SUNDRY NOTICES AND REPORTS ON WELLS
Do not use this form for proposals to drill or to re-enter an abandoned well. Use Form 3160-3 (APD) for such proposals.

2. Name of Operator
DEVON ENERGY PRODUCTION COMPANY, LP

8. Well Name and No.
TODD 15 H FEDERAL #8

THIS LOCATION HAS BEEN DOWNSIZED FROM 175' X 175' BY 30' ON THE EAST SIDE.

Todd 15 fed #8

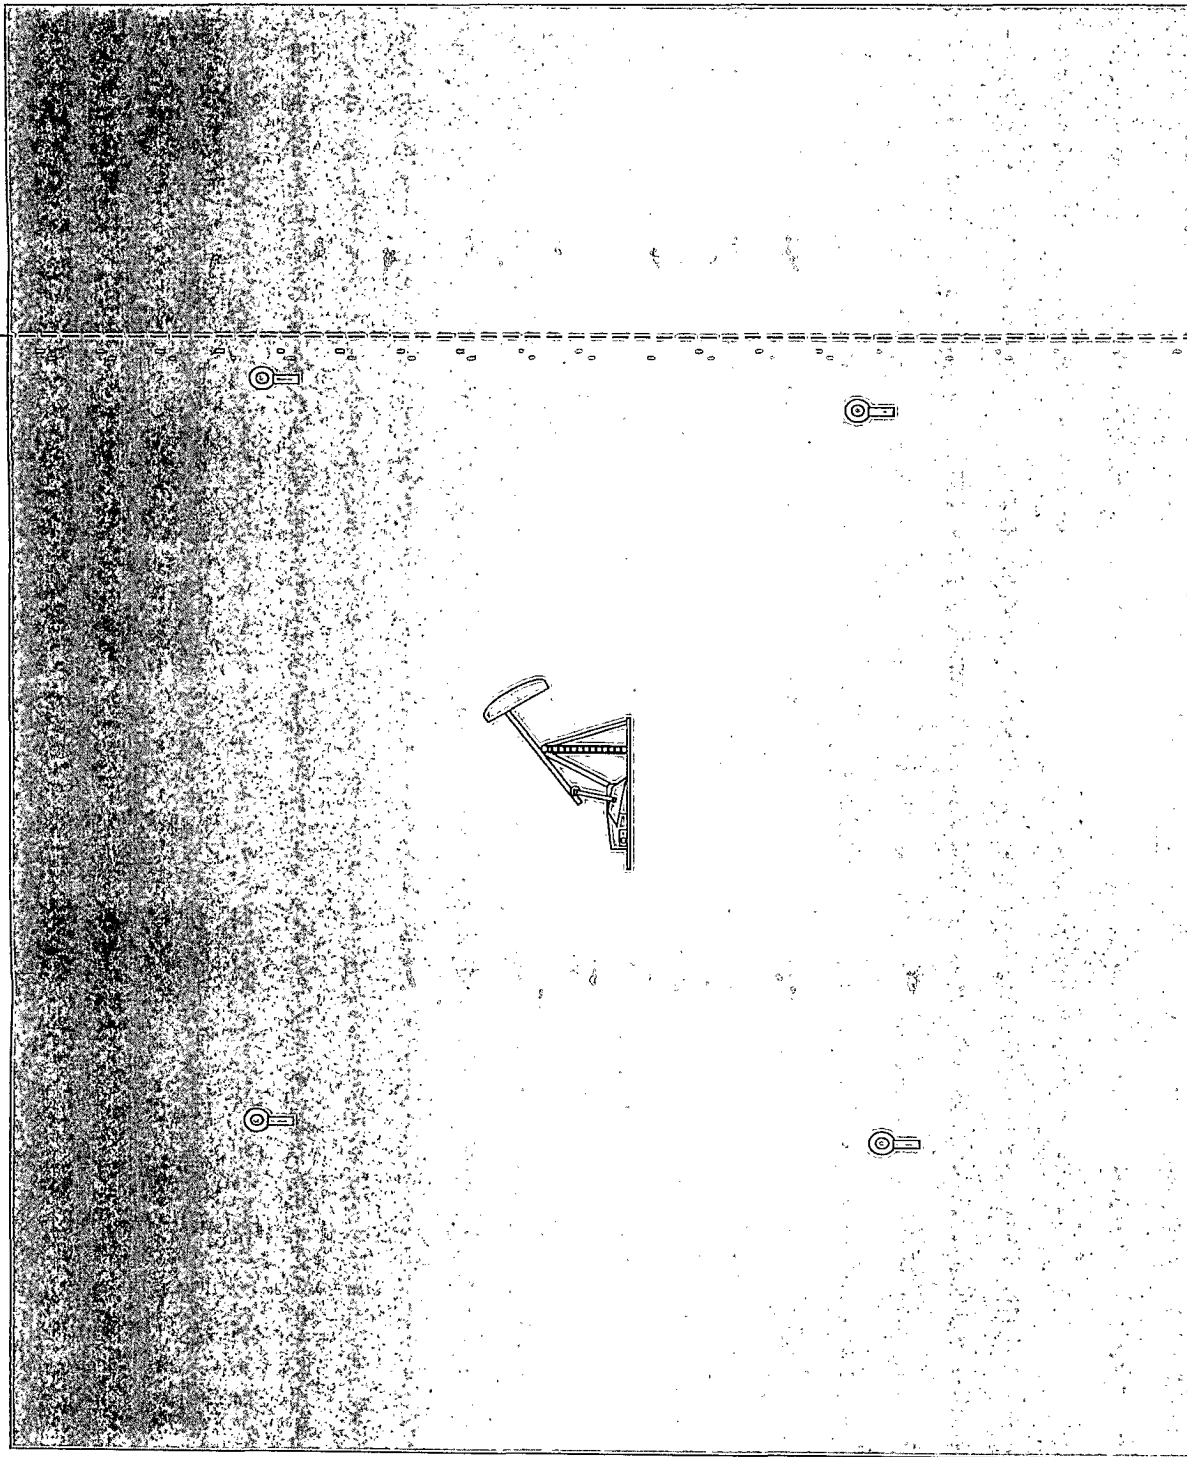
* Diagram is not accurate, stockpiled topsoil should be respread to keep soils viable. Current conditions facilitate erosion on NE Corner of the location. Take actions to correct.
